ERFV402XSEU

16844

Przewodnik Dokumentacji Technicznej

Notatki

See fig.5152369B.

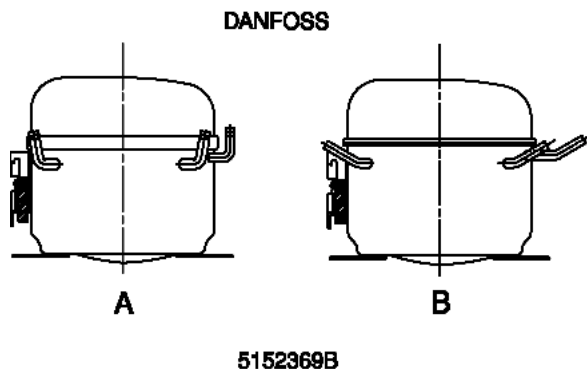
0518016: COMPRESSORI DANFOSS TUBI PIEGATI

As of the month of April '98 (serial no. 80410.0001), the Danfoss compressors are being used in place of the Necchi models on the "competitive" Ariston and Indesit refrigerators (2 motor version).

The Danfoss compressors being used have the service, intake and drain tubes bent at an angle of 90° and turned upwards. This makes them not interchangeable with respective Danfoss models with the inclined tubes (050298=TL4F - 054725=TL5F - 046374=TL6F).

Below is a list of Danfoss compressors with bent tubes (TP):

057138- TL4F Compressor (fridge) for 280-352-382 liter combos;

057009- TLS6F Compressor (freezer) for 320-352-382-402 liter combos;

057010- TL5F Compressor (fridge) for 402 liter combos.

The Danfoss compressors use a condenser (056669) which is different than the one used for the Necchi compressors (047410).

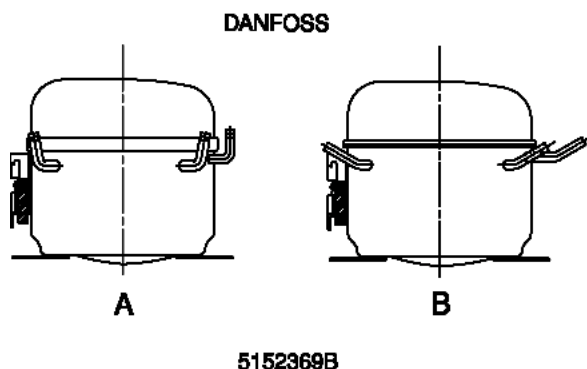
n1030037: New compressors Danfoss (high efficiency) - bent tubes on combined 2-engined products (Carinaro)

From September-2001 the production of Carimano (Italy) is using on the combined, ventilated products Ariston, which are convex and 2-engined, new compressors Danfoss 220-240V/50Hz (gas R134A) (high efficiency):

- section of freezer TLY5FK (with running condenser)

- section of fridge TLES4F

We remind you that compressors, used on the combined and 2-engined products, have service tubes, aspiration and drain: these are of 90° bent and turned upward. For this reason these kinds of compressors are not interchangeable with the compressors Danfoss with the bent tubes (see Figure 5152369B).

New components:

085076 - COMPRESSOR DANFOSS TLY5FK 220-240/50 R134A T/P

085077 - COMPRESSOR DANFOSS TLES4F 220-240/50 R134A T/P

046312 - PLATE FOR FIXING CONDENSER

085962 - RUNNING CONDENSER 3 MF (DUCATI)
